UNITED STATES PATENT AND TRADEMARK OFFICE

APPLICATION NO.	FILING DATE	FIRST NAMED INVENTOR	ATTORNEY DOCKET NO.	CONFIRMATION NO.
09/891,589	06/27/2001	Kiichiro Takahashi	684.3203	2104

Office Action Summary	Application No.	Applicant(s)	
	09/891,589	TAKAHASHI ET AL.	
	Examiner	Art Unit	
	Leonard S Liang	2853

FIG. 2

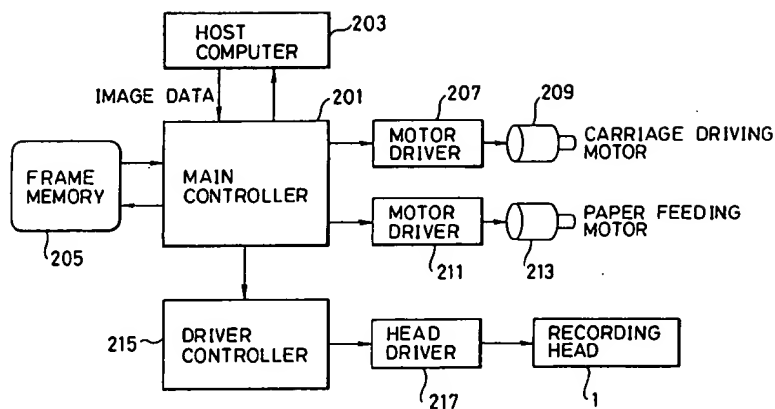
14. Claims 1-3 are rejected under 35 U.S.C. 102(b) as being anticipated by Takagi (US Pat 5384587). Referring to claims 1-3, Takagi discloses an ink jet recording apparatus/method for effecting recording on a recording material by ejecting ink (See figure 1; column 1, lines 8-11), as well as a data processing method of processing data to be supplied to an ink jet recording apparatus for effecting recording on a recording material (See column 1, line 9; The disclosed generation of clear images represents a type of data processing method), both with relative scanning movement by ejecting ink with relative scanning movement between a recording head and the recording material (See figures 1-18; column 1, lines 29-34); an obtaining means/step for obtaining information indicative of an amount of ink to be ejected to each of unit areas provided by dividing an area in the neighborhood of a boundary between adjacent bands of scanning recording material (See figure 2, references 201 and 203; column 4, lines 63-64; column 5, lines 14-17; and column 7, lines 18-25); and a control means/step for controlling an amount of being to be ejected to the unit area on the basis of the output of the obtaining means (See figure 2, reference 201; column 4, lines 63-64; and column 7, lines 9-33),

FIG. 4

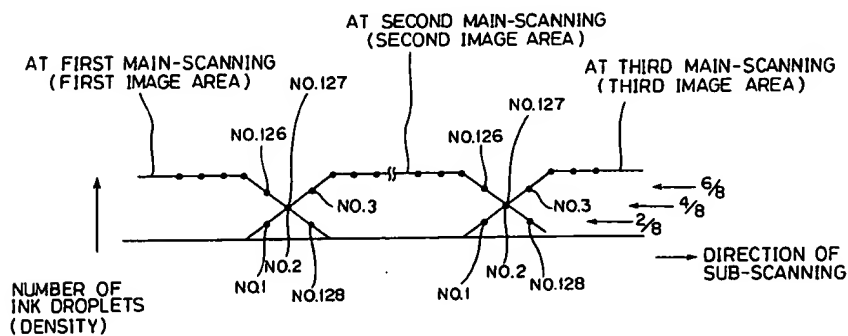
wherein the unit areas astride the boundary between adjacent one of the bands (See figure 4; column 11, 47-53).

Takagi discloses, with respect to claims 4-7, 11, and 13-14 an ink jet recording apparatus for effecting recording on a recording material by ejecting ink (See figure 1; column 1, lines 8-11) using a recording head having a plurality of recording elements (see column 1, lines 10-11), with the ink jet recording apparatus comprising: a recording scanning means for effecting recording with relative scanning movement between the recording head and the recording material in a main scan direction (See figures 1-18; column 1, lines 29-34) and a subscanning means for imparting relative scanning movement between the recording material and the recording head in a direction which is different from the main scan direction substantially each time after completion of recording scan in the main scan direction (See figures 1-18; column 1; lines 29-34), wherein the unit areas exist astride the boundary between adjacent one of the bands (See figure 4; column 11, 47-53).

FIG. 3

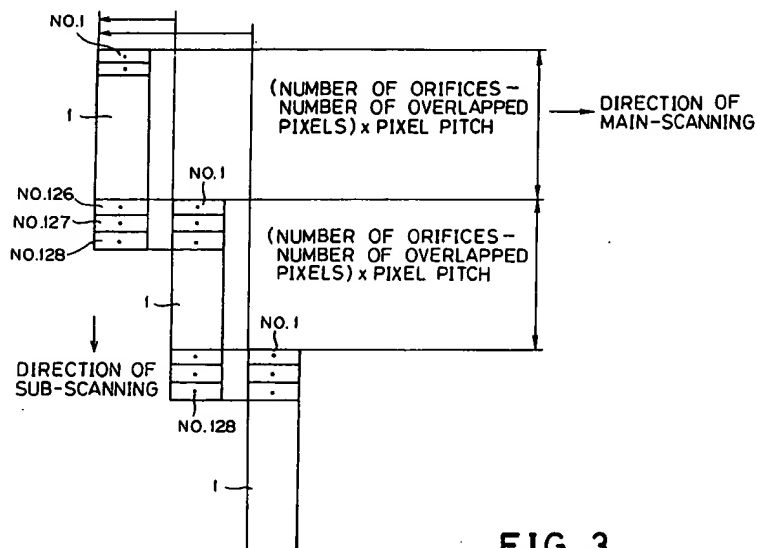
However, Takagi does teach, with respect to claims 4-6, 11, and 13 that "The number of ink droplets that may be landed on one pixel may be controlled based on the density data." (See column 4, lines 63-64). Furthermore, in regards to Figure 3, Takagi teaches "the number of ink droplets forming each pixel according to image data differs from each other." From the descriptions of figures 3 and 4, it is clear that each of the unit areas are divided in the

neighborhood of a boundary between adjacent bands of scanning recording of the recording head on the recording material.

Therefore, in order to properly enable the production of the different number of ink droplets that may be landed on one pixel, there must be an implicit means for counting the ink ejection data number. Thus, it will be assumed that Takagi implicitly implies a dot count means for counting the ink ejection data number for each of the unit areas provided by dividing an area in the neighborhood of a boundary between adjacent bands of scanning recording of the recording head on the recording material, though it does not explicitly state so. Furthermore, Takagi teaches, with respect to claim 5, "When recording is performed on the recording sheet at the first main-scanning time, the orifices Nos. 1, 2, ..., and 128 are used. At this time, as shown in FIG. 4, the numbers of ink droplets discharged from the orifices Nos. 126, 127 and 128 are determined as $N \times 6/8$, $N \times 4/8$ and $N \times 2/8$ respectively for forming the first image area." (See figures 3 and 4; column 7, lines 53-59) Here, the factors $6/8$, $4/8$, and $2/8$ represent different weights that are applied to the ink ejection bands. Next, Takagi teaches, with respect to claim 6, "a recording sheet is moved or sub-scanned upward by 125 pixels so that the orifices Nos. 1, 2, and 3 overlap part of the first image area formed by the orifices Nos. 126, 127 and 128 respectively..." (See

figure 3; column 7, lines 60-64) Thus Takagi discloses that the dot count means not only counts the ink ejection data number with weighting for each of the bands, but it also counts the ink ejection data number with weighting which is different in the sub-scan direction.

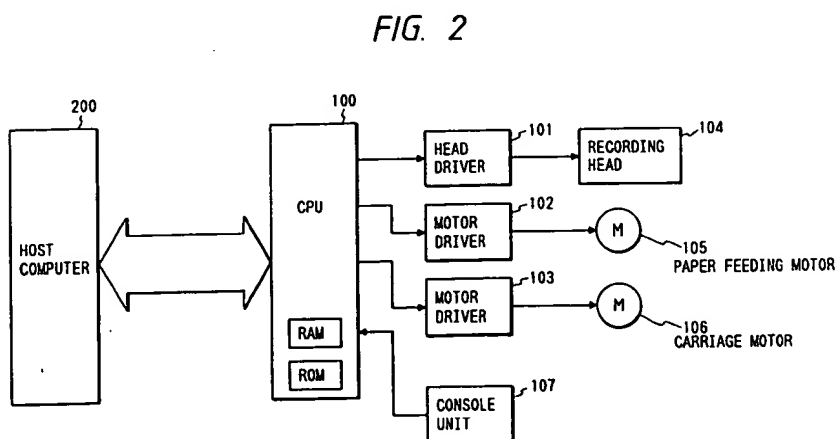
Nagoshi teaches, with respect to claims 4, 11, and 13. "The CPU 100 controls the driving operation of the carriage motor 106 so that the single- and multi-pass print modes have different scan speeds. When the CPU 100 receives data from the host computer 200, it drives the carriage motor 106 to cause the carriage unit 2 to travel, thereby starting the main scan operation" (See figure 2, references 100, 106, and 200; column 4, lines 32-39). Thus, Nagoshi discloses a CPU 100, which not only receives data (i.e. dot count data [of which data about distance from boundary is inherent]) from the host computer, but also from that data, controls scanning speed, which directly relates to thinning rate in this invention. Thus Nagoshi discloses a determining means for determining a thinning rate for each of the unit areas on the basis of an output of said dot count means and a distance from the boundary.
